TECHNICAL INSTRUCTION

TI 107

NETWORK RAIL - SIGNAL ENGINEERING

Thales AzLM Axle Counter System – Reliability Checks and Improvements

Figure 1

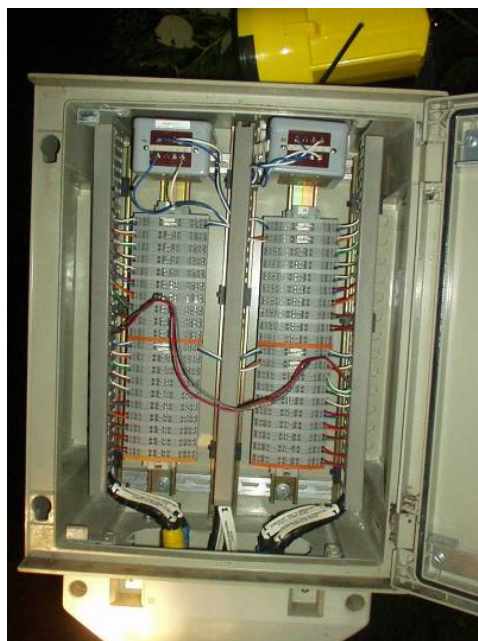
- b) On early AzLM Axle Counter projects a decision was taken to provide two sets of WAGO terminations in the line side locations (see Figure 1). This was to ease maintenance testing in the event of cable failure. However, the fact that there were now two termination points effectively doubled the potential failure points and led to a decline in reliability. Where this is the case the additional WAGO termination block may have to be removed to reduce the number of failure points. An inspection shall be carried out and all such installations identified and reported back to HQ Signal Engineering (email david.mahoney@networkrail.co.uk). An assessment of the workload and costs involved to rectify this deficiency will then be carried out centrally.
